Fryberger Arena

Accessibility Review

Transition Plan - (location/priority)

Photo 5: Remove the privacy wall at the single user accessible toilet room (it currently obstructs maneuvering clearance at the door). A privacy lock is already provided.

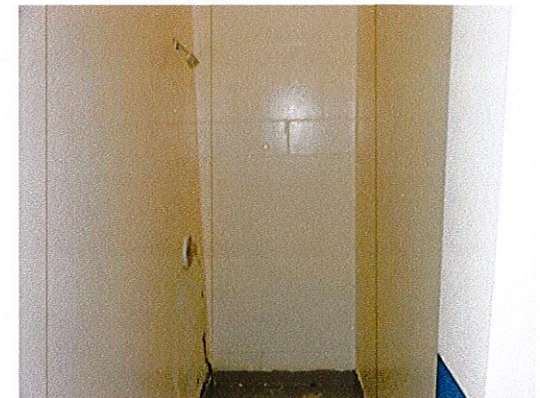
Location JQP # / Item #	Solution / Comments	Qty	Unit Cost	Total Cost	Priority	Estimated Compl. Date	Person Responsible	Actual Compl. Date	Actual Cost
Single User Toilet Room									
22B1 16430	Relocate compliant sign to the wall adjacent to latch side of door, 48" minimum to the baseline of the lowest Braille characters and 60" maximum to the baseline of the highest tactile character. ICC/ANSI 703.3.10, 703.4.5	1	\$40	\$40	3				
Upper Level									
14D1 16422	Provide a fully compliant elevator to provide access between levels. MN 1341 1104.4 and 402.2 <i>There is not currently an accessible route to the upper level. The upper level provides toilet rooms, concessions and a heated viewing area. Photo 2.</i>	1	\$250,000	\$250,000	3				
20D 16425	Provide door hardware that does not require grasping, pinching or twisting to operate, such as lever. ICC / ANSI 404.2.6	2	\$250	\$500	3				
				<i>Location Subtotal:</i>					\$250,500
